MIL-PRF-19500/240U
w/AMENDMENT 3
14 April 2026
SUPERSEDING
MIL-PRF-19500/240U
w/AMENDMENT 2
24 July 2024

PERFORMANCE SPECIFICATION SHEET

SEMICONDUCTOR DEVICE, DIODE, SILICON, RECTIFIER, AXIAL LEADED AND SURFACE MOUNT PACKAGES, TYPES 1N645-1, 1N647-1, AND 1N649-1, QUALITY LEVELS JAN, JANTX, AND JANTXV

FIGURE 1. Physical dimensions of axial leaded package (DO-204AH).

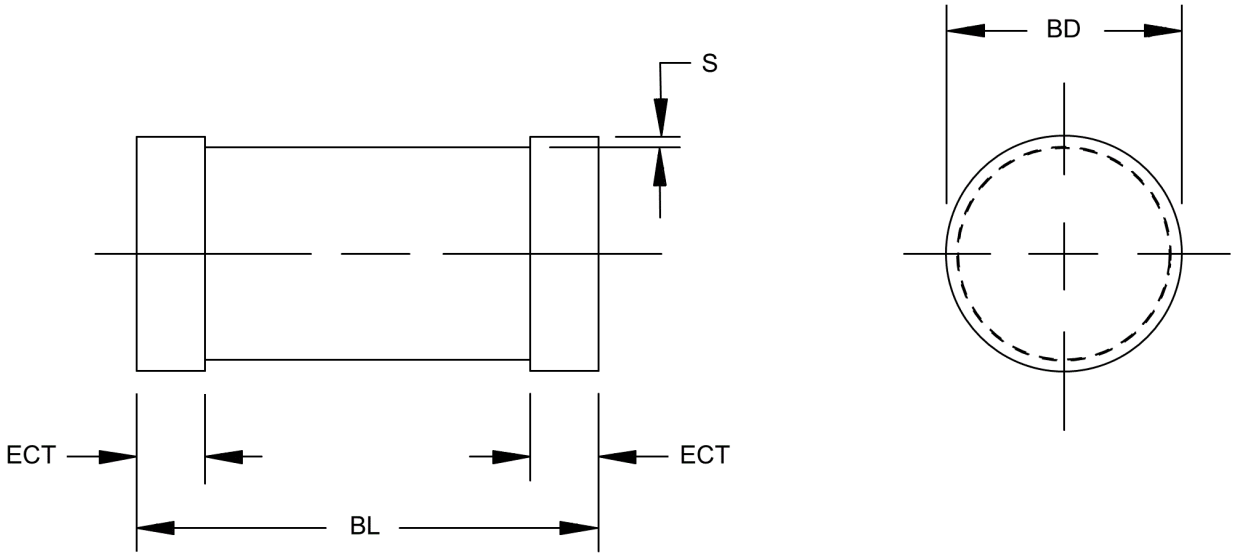
Symbol	Inches	Inches	mm	mm	Notes
	Min	Max	Min	Max	
BD	.055	.090	1.40	2.29	
BL	.120	.200	3.05	5.08	3
* LD	.018	.022	0.46	0.56	2
LL	1.000	1.500	25.40	38.10	
LU		.050		1.27
